In the matter of An application for approvals by Mt Iron Junction Limited (**MIJL**) to develop approximately 263 high-density residential dwellings, a childcare centre, a retail building, a restaurant, a service station, and parks at 237 Wānaka to Luggate Highway, Wānaka ('Mt Iron Junction Housing Scheme').

Statement of Planning Evidence of Helen Elizabeth Dempster for the New Zealand Transport Agency

Dated 25 August 2026

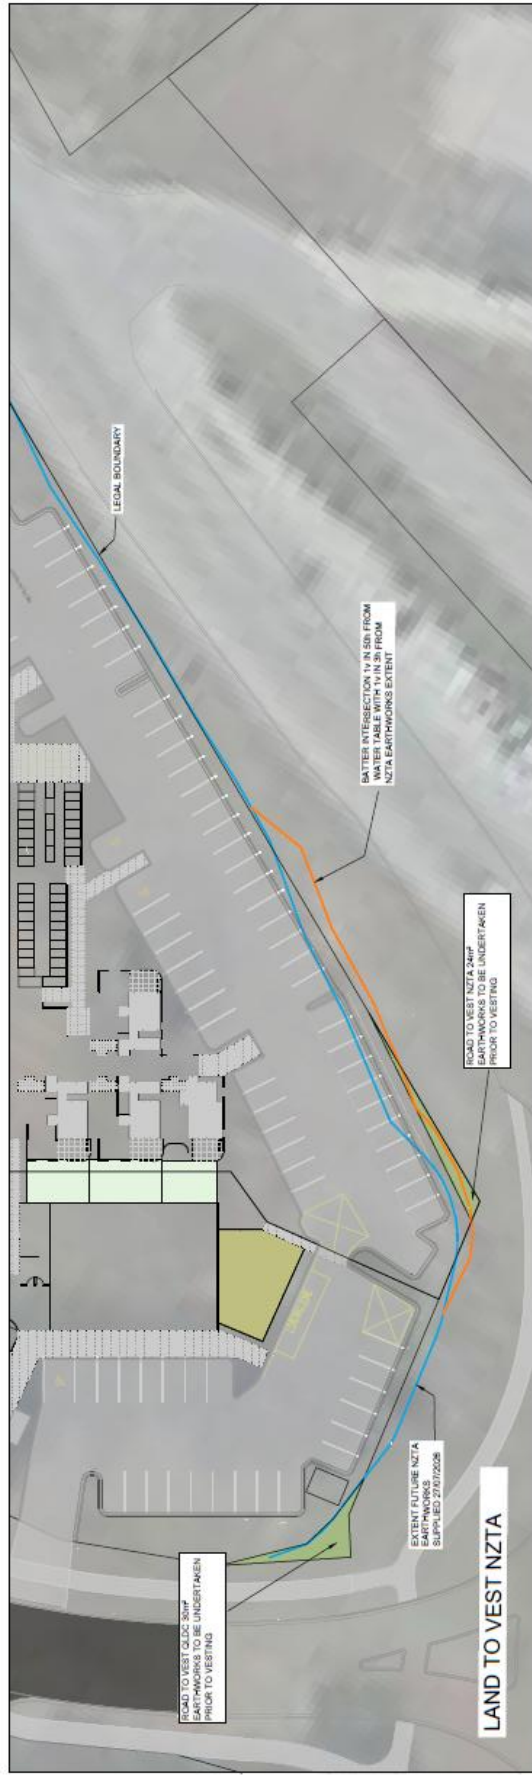
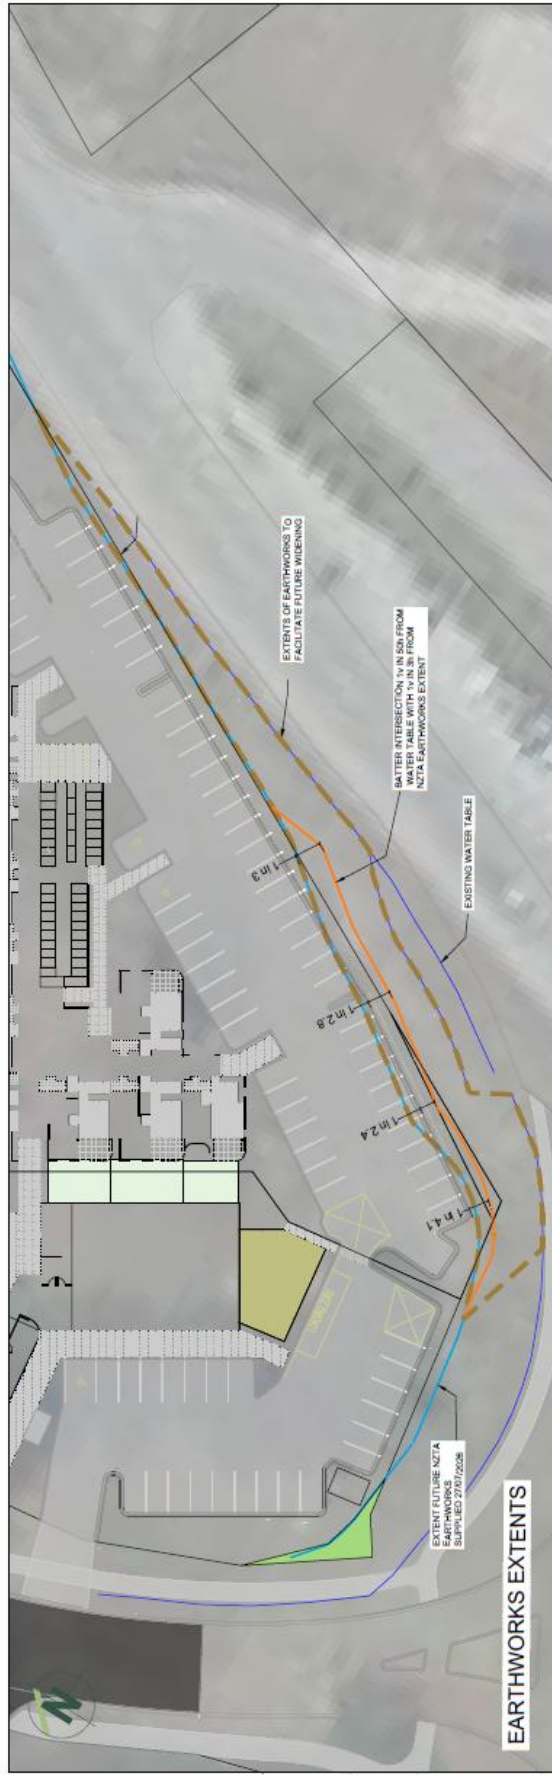
5.1 It is stated in paragraph 59 of the Memorandum of Counsel submitted by MIJL's legal counsel that NZTA confirmed that the plans provided in Appendices D (**revised scheme plans**) and E (**revised engineering plans**) of MIJL's response to Minute 7 of the Panel outline a workable and acceptable layout that will not foreclose the ability for the existing roundabout to be upgraded to dual lanes in the future and that the layout also enables relocation of related infrastructure such as stormwater swales that would need to occur as part of an upgrade to the roundabout. I wish to clarify that MIJL has not previously consulted with NZTA on those specific revised scheme and engineering plans as inferred in the aforementioned Memorandum. Rather, the plan upon which NZTA provided those comments to MIJL were based on the plan attached as Appendix 1 to this Evidence (**the Appendix 1 Plan**).

5.2 The Appendix 1 Plan shows two parcels of land that are intended to be vested in NZTA, to enable the future upgrade of the existing roundabout. As can be seen on the Appendix 1 Plan, one of those parcels of land is located west of Junction Road, while the second is located east of Junction Road. These two parcels are identified as Lots 700 and 701, respectively, on the revised scheme plans.

- 5.3 On the revised scheme plans, Lot 700 is noted to have an area of 130 square metres, and Lot 701 is noted to have an area of 20 square metres. On the Appendix 1 Plan, the land parcel equivalent to Lot 700 has an area, as noted in the text box, of 335 square metres, and the land parcel equivalent to Lot 701 has an area of 24 square metres. In other words, there are differences in the land areas of the two lots intended to be vested as road, when comparing the Appendix 1 Plan with the revised scheme plans.

- 5.4 I have discussed these differences via email correspondence with a MIJL representative, Peter Joyce, and he has indicated that the reference to 335 square metres on the Appendix 1 Plan was meant to be updated but was accidentally missed. Mr Joyce advised that the area of Lot 700 is 133m², but has been rounded down to 130 square metres on the revised scheme plans. Similarly, he has advised me that Lot 701 has an actual area of 24m², but due to rounding, is shown as 20m² on the revised scheme plans.

- 5.5 NZTA engaged WSP to determine the area of land that would be required to accommodate a second circulating land on the roundabout and the relocation of associated infrastructure, and WSP assessed the suitability of the Appendix 1 Plan. I accept that the reference to Lot 700 having an area of 335 square metres is not accurate, and that the area should instead be 133 square metres.

- 5.6 I suggest to the Panel that, if it is minded to grant the approvals:
- a. the revised scheme plans should be further amended to accurately reflect the correct area of Lots 700 and 701, which NZTA and MIJL previously agreed to, being 133 square metres and 24 square metres respectively;

- b. the Panel request MIJL to make changes that would be necessary to align the revised engineering plans (Appendix D of MIJL's response to Minute 7) with the Appendix 1 Plan; and

- c. the Panel impose a condition that Lots 700 and 701 are vested to NZTA as Road with any costs of the legalisation process (e.g. legal drafting fees, LINZ fees, survey fees) to be the responsibility of the applicant.
